## Firmware 2.06.3 bug list:

## List of bugs/improvement requests

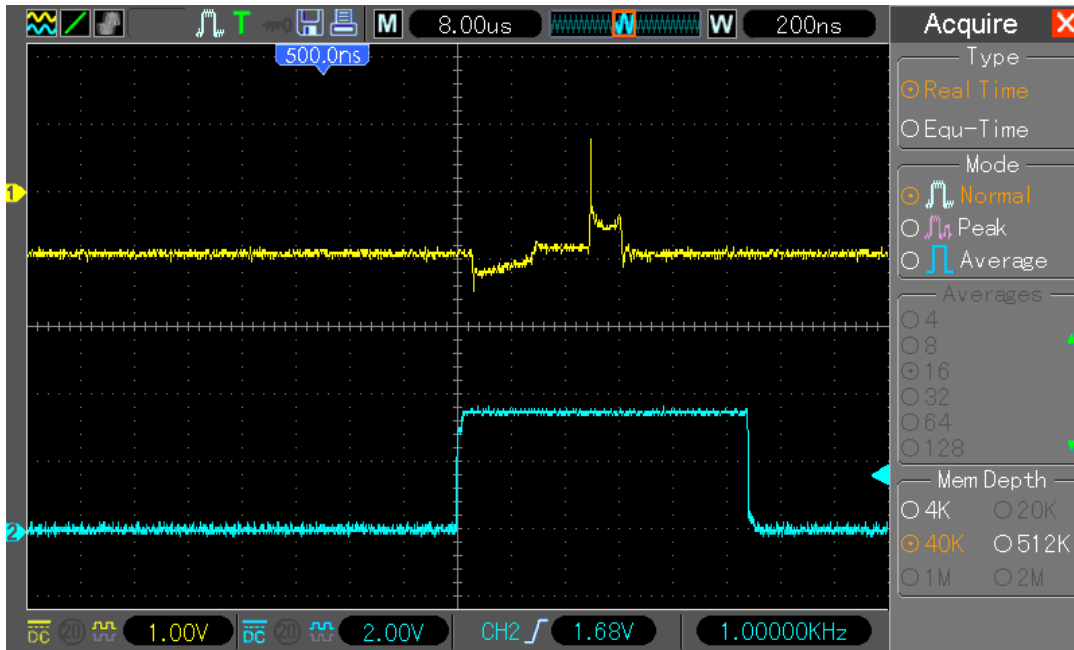
8. In single window, sample memory  $\geq 40k$ , both channels (ch1, ch2) enabled and time base from 400ns/div up to 2ns/div the position change (fine and coarse) control is not working. Only scale is moving, but not the waveform. See attached picture to understand issue:

with 4k memory when changing position waveform is moving

with 40k and above, when moving changing time base position waveform is NOT moving when in RUN mode (but works in STOP mode)

7. This is improvement proposal and not a bug. It has been removed from to-do as “not important”.
8. **This is a very unfortunate bug; possible workaround is to use dual window mode or less memory depth (both with disadvantages)**

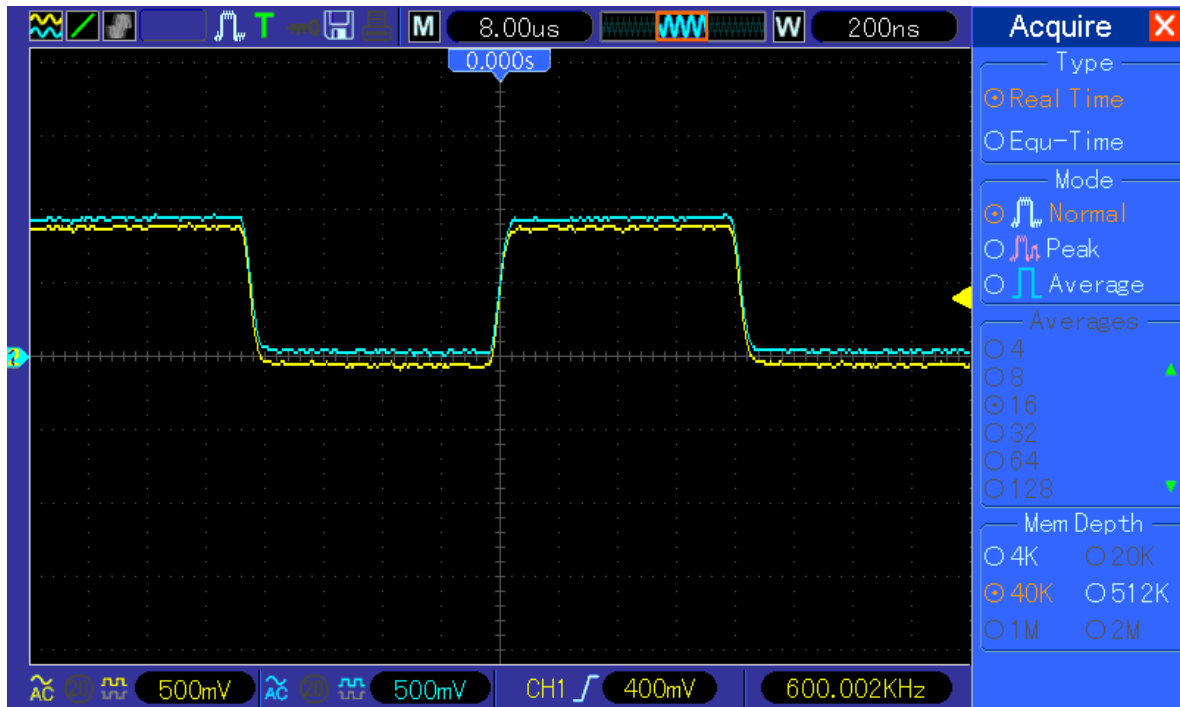
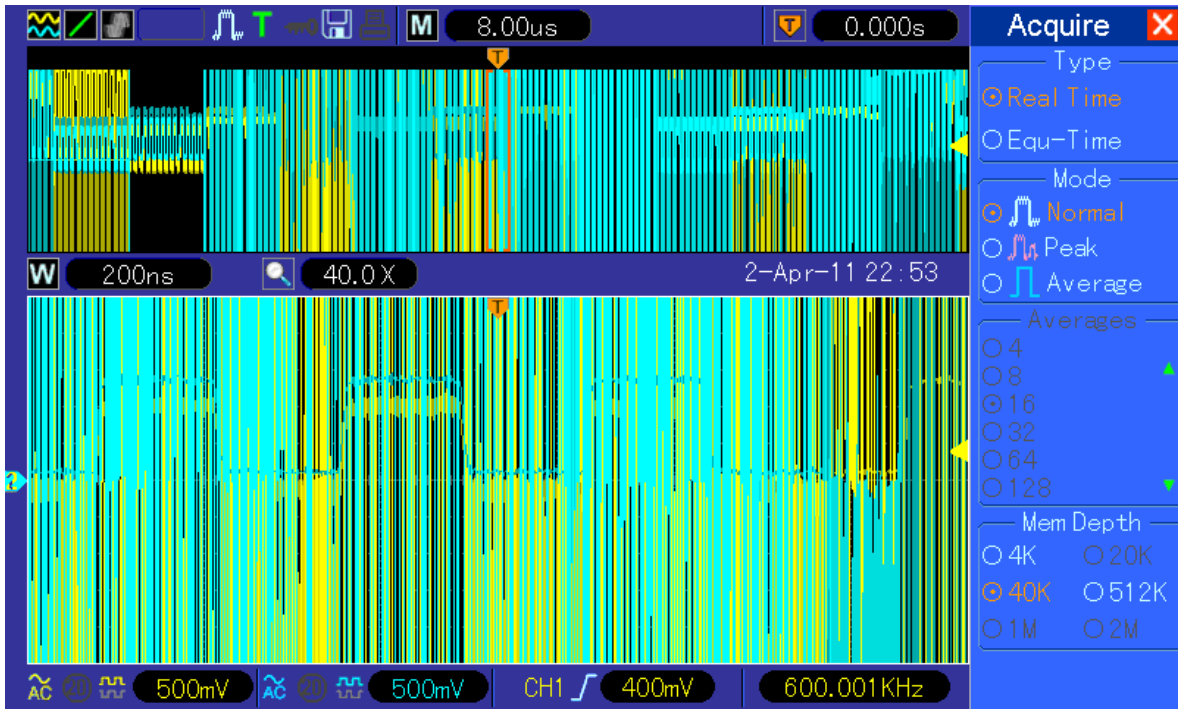
9. In single window mode, sample memory 40k, both channels (ch1, ch2) enabled – while switching to dual window mode artifacts on screen and DSO later crashing and not responding.

**Artifacts disappear when changing timebase just after switch to dual window, so just an init error?**

Set like on picture

and switch dual window mode to see artifacts like this:

9. ~~Workaround is to change Timebase (just one step forward and back) right after dual window enabled. Note – the main window (top) need to be activated, the bug have something to do with main TB buffer initialization.~~

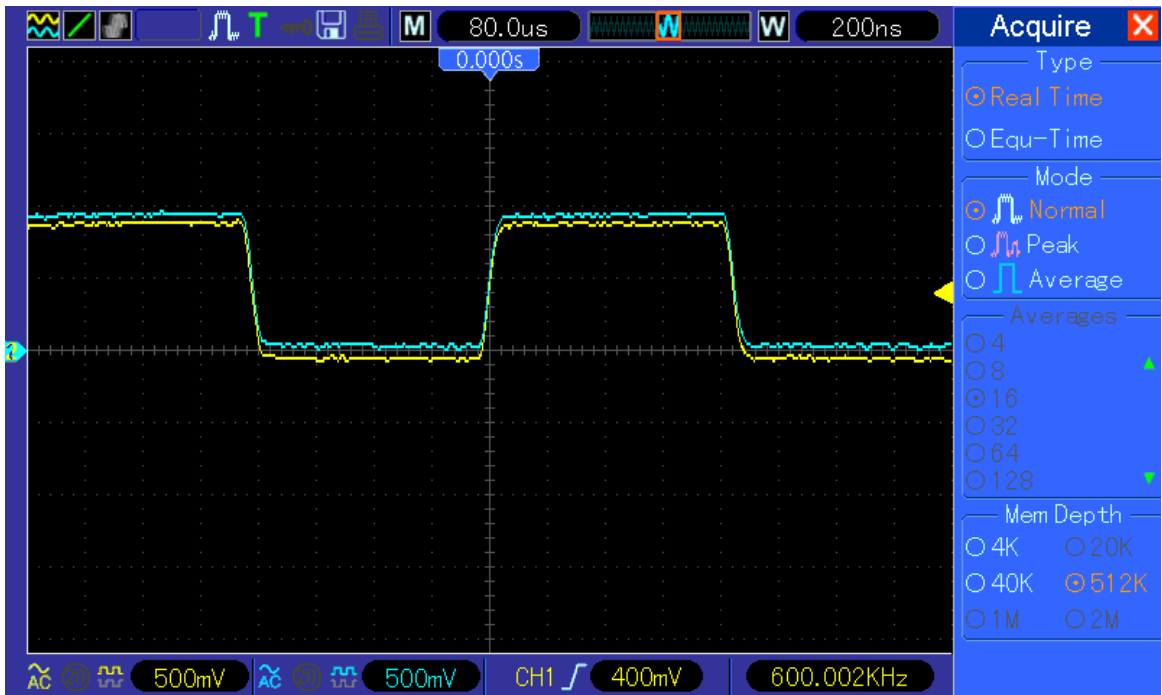
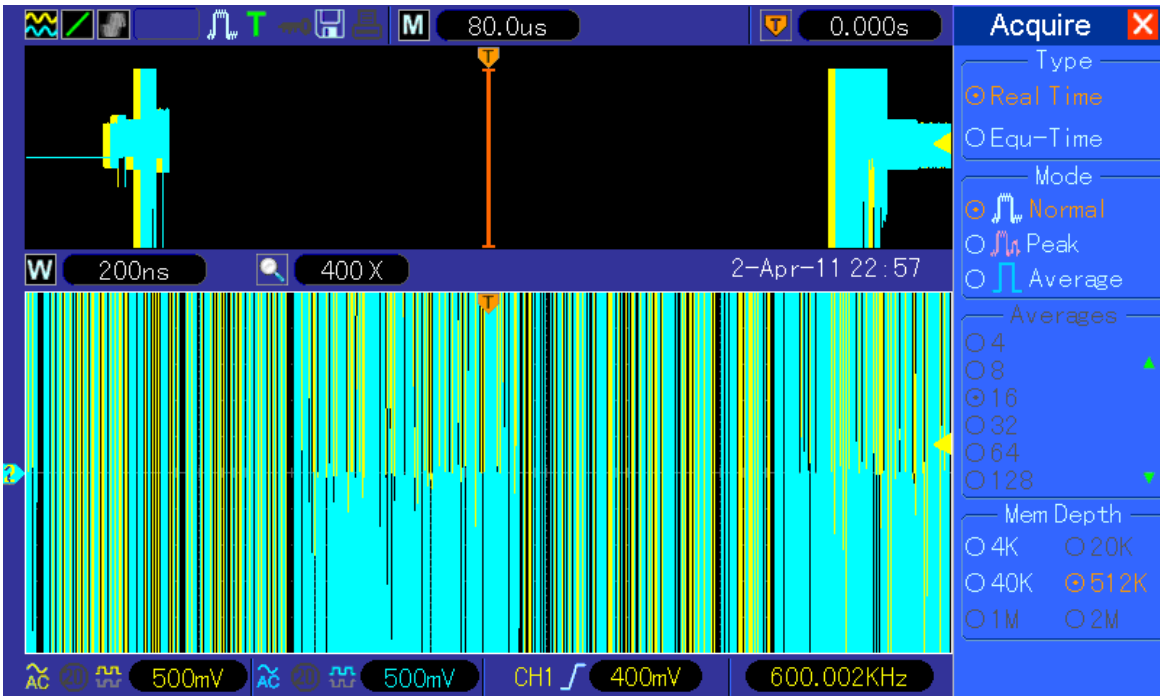
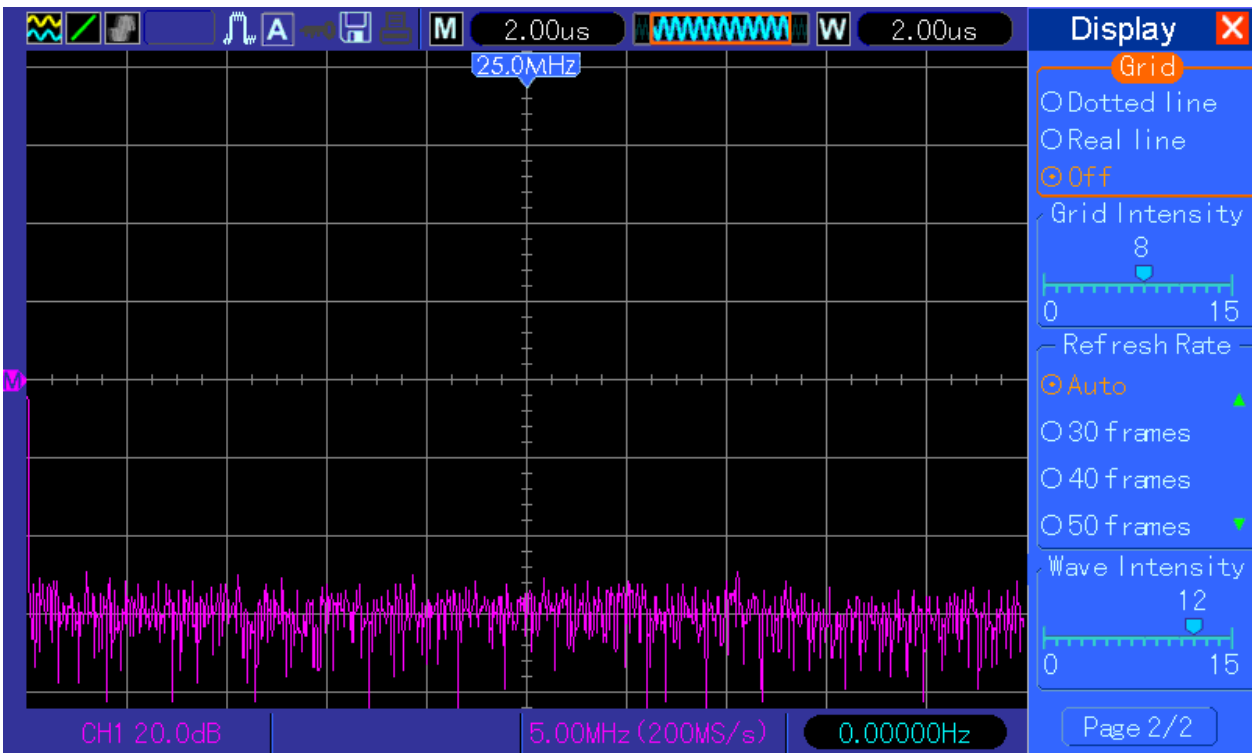
10. In single window mode, sample memory 512k, both channels (ch1, ch2) enabled – when switching to dual window mode artifacts on screen and DSO later crashing and not responding

**Artifacts disappear when changing timebase just after switch to dual window, so just an init error?**

Set DSO like on picture

and switch dual window mode to see artifacts like this:

10. Workaround is to change Timebase (just one step forward and back) right after dual window enabled. Note — the main window (top) need to be activated, the bug have something to do with main TB buffer initialization.
11. This is improvement proposal and not a bug.
12. Use my firmware (2.06.3\_120507.6), I removed that bug.
13. Use DC trigger coupling or “add offset” when you set trigger point. On some other good known DSOs (e.g. Tektronix TDS7xxx) there is exact the same DC-signal/AC-trigger “dependency” (bug) and nobody ever complained about.

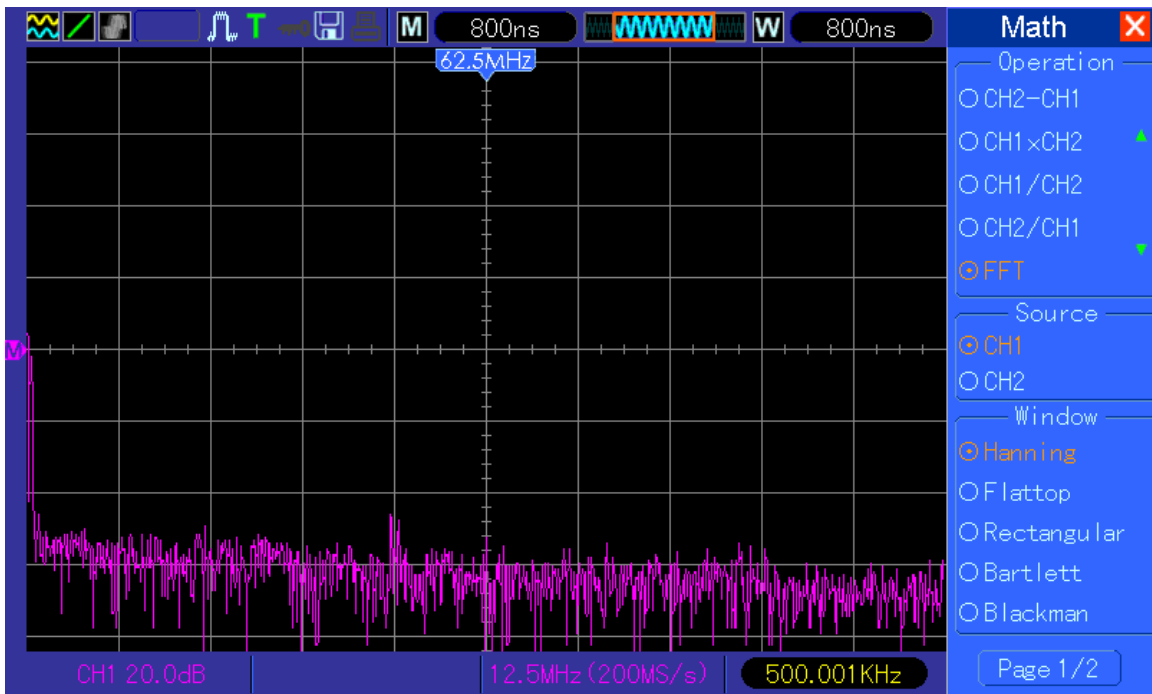
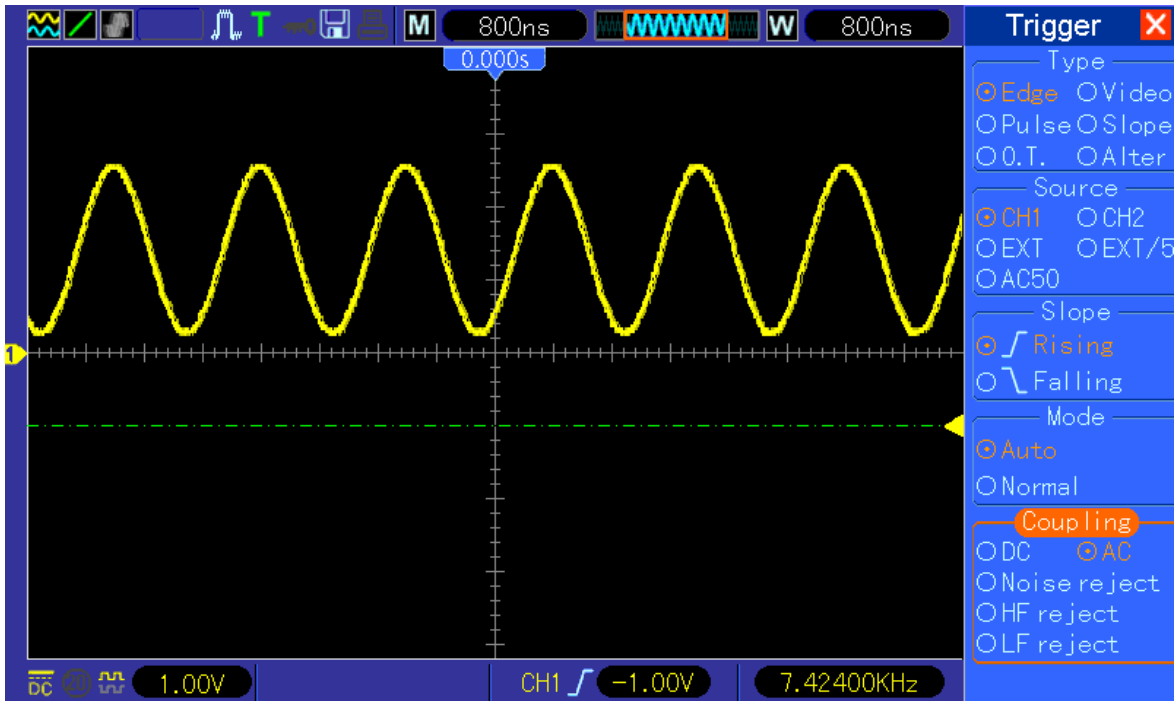
12. In FFT mode “Full span” is higher than Nyquist (sample rate / 2 )  
 Example: 800ns/DIV, sample rate is 200MSs, full span 125MHz. Easy to fix by enabling from

800ns/DIV to 20ns/DIV 1GSs sampling (when 4k memory or FFT enabled)

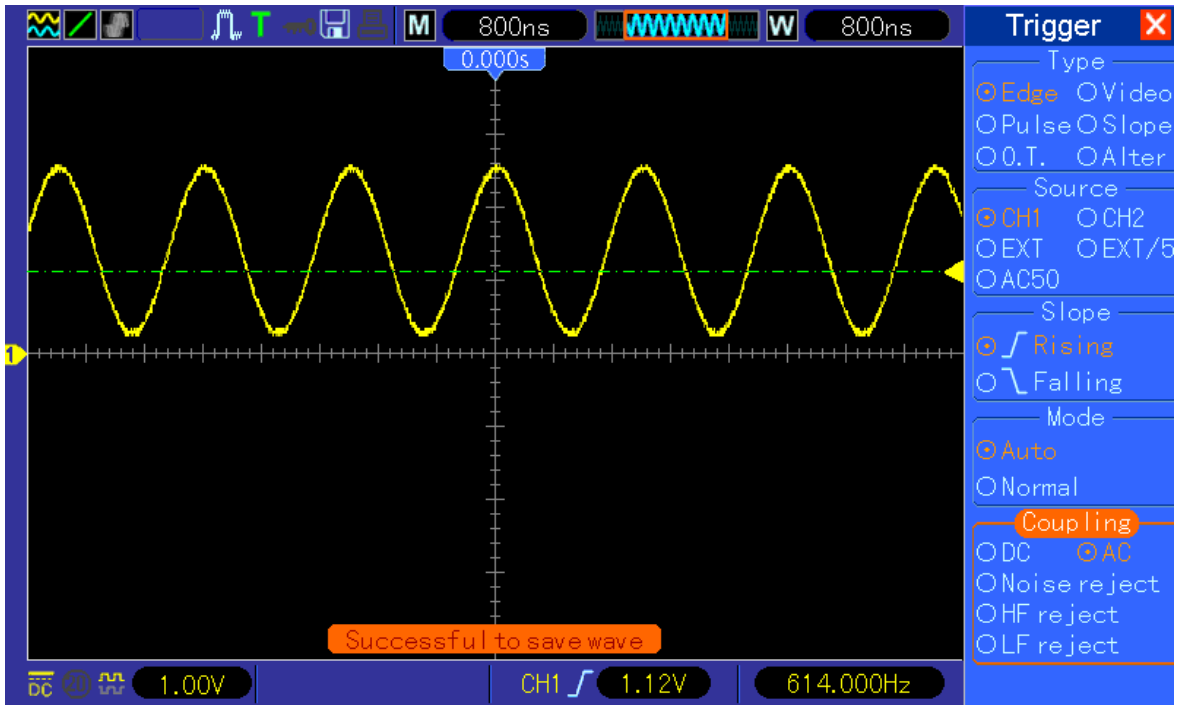
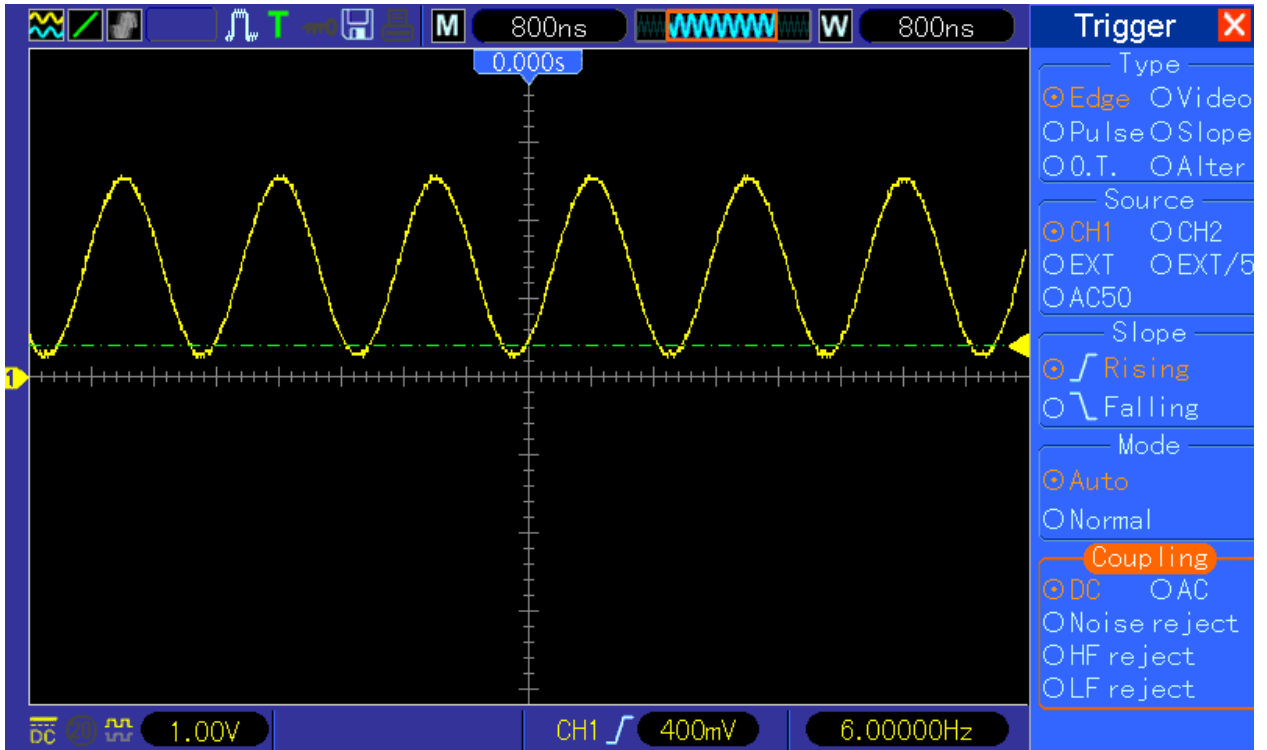
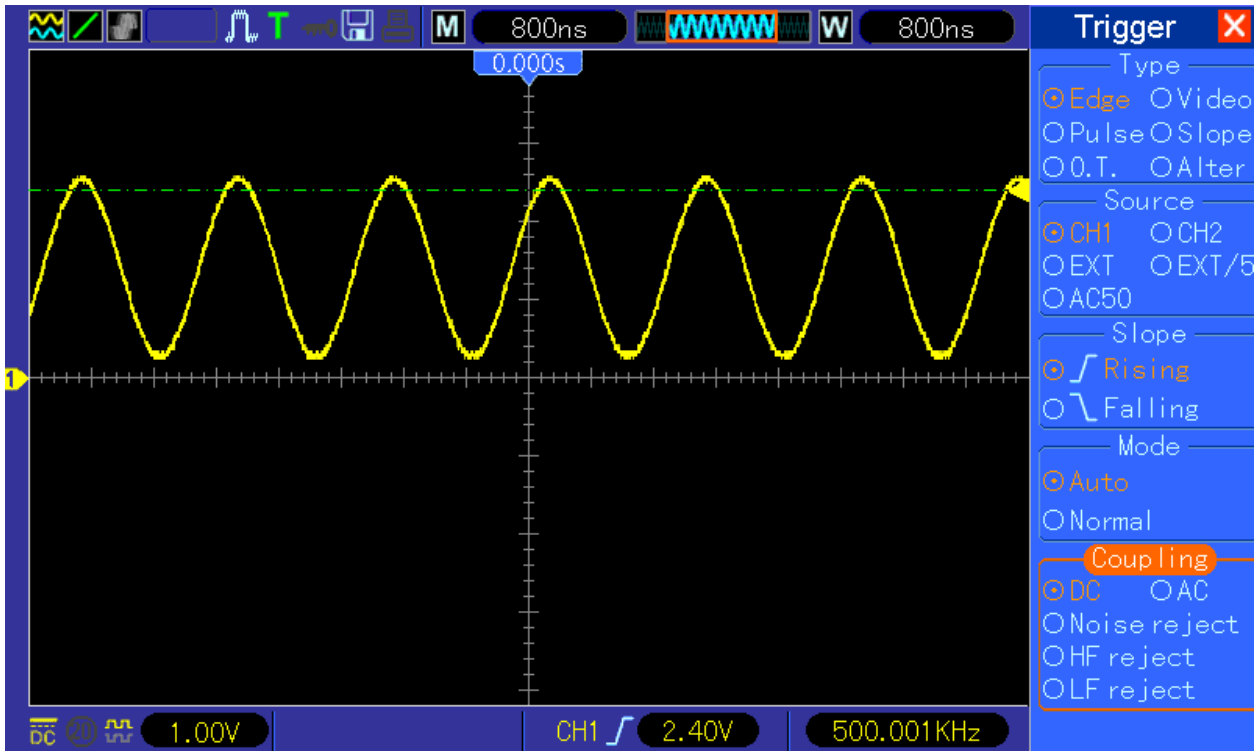
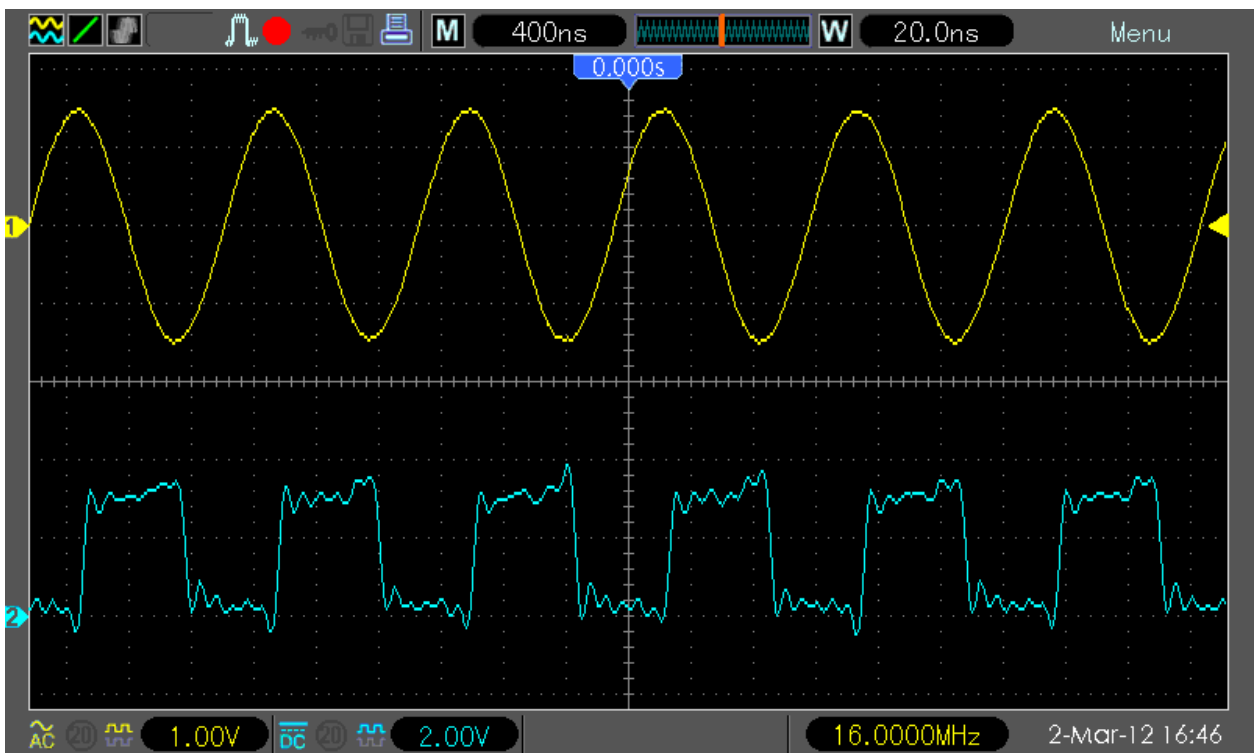
13. AC trigger indicator and line wrong. Set ch1, signal DC coupled, trigger AC coupled. The trigger lowest level below signal :

highest level only mid of signal

But both should look like when trigger coupled in DC mode:
